**Madison College
Urban Design Commission
Meeting**

12/13/2023

ELEVATION PROGRESS | WISCONSIN AVE

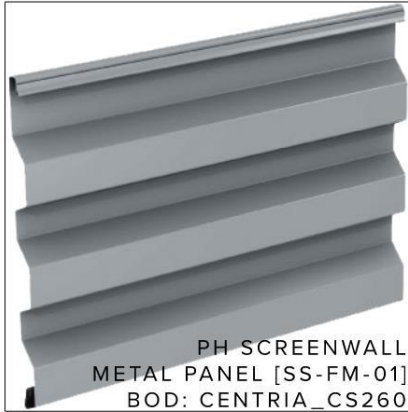
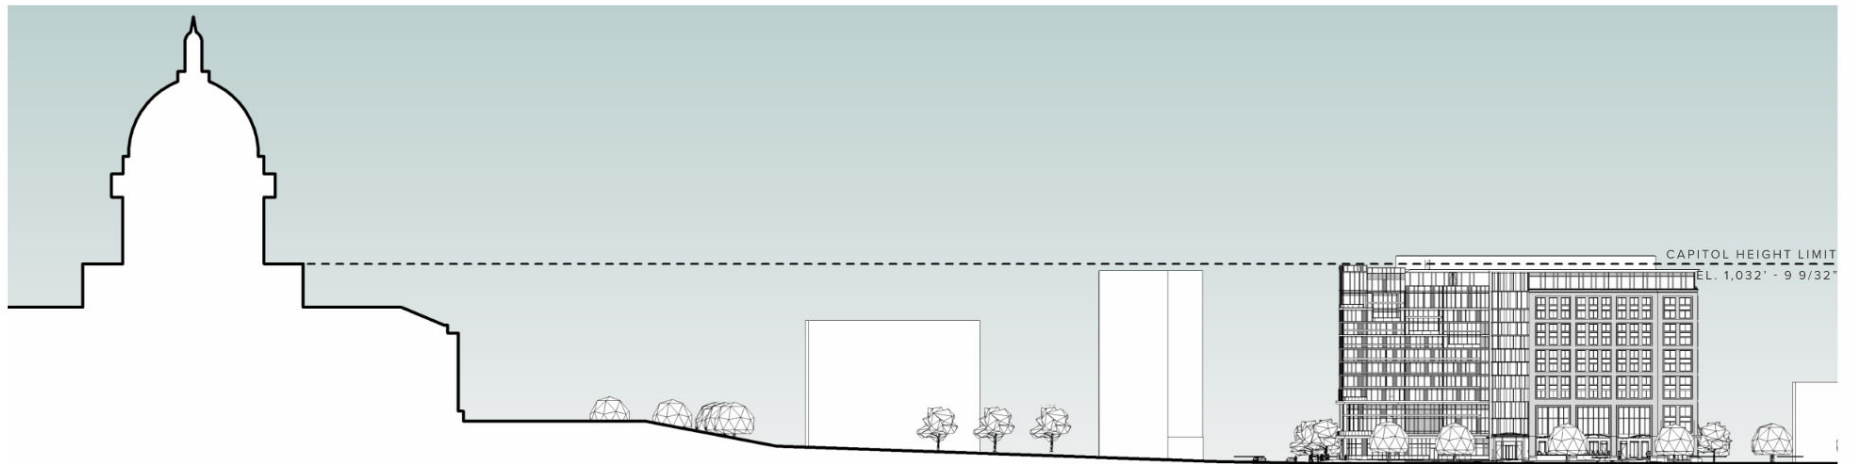
Utilize the same window patterns, treatments and detailing, especially at the corner of Dayton and Wisconsin.

Creating two buildings that look like different hotels, including extending the unique identity of the Autograph hotel along Dayton so that it does not look like the Residence.

DESIGN COMMENTS/RESPONSES:

- **BALANCE BETWEEN GLAZING AND MASONRY**
 - PUNCHED WINDOW GROUPINGS HAVE BEEN REVISED
 - WIDER VERTICAL AND HORIZONTAL EXPRESSIONS HAVE INCREASED THE AREA OF MASONRY
- **PEDESTRIAN SCALE**
 - ADDED GREEN SPACE ALONG SIDEWALK FOR AN ELEVATED PEDESTRIAN EXPERIENCE
 - SINGLE CANOPY REVISED TO A SERIES OF DYNAMIC CANOPY FORMS ALONG SIDEWALK
- **WISCONSIN AVENUE TERRACE AND SITE**
 - DEPTH OF TREE TERRACE TO REMAIN
 - WIDTH OF SIDEWALK TO REMAIN
 - HOTEL GUEST DROP OFF AREA RELOCATED WITHIN PROPERTY LINE
 - ADDED 'PLANTING BUFFER' BETWEEN DROP OFF AREA AND SIDEWALK
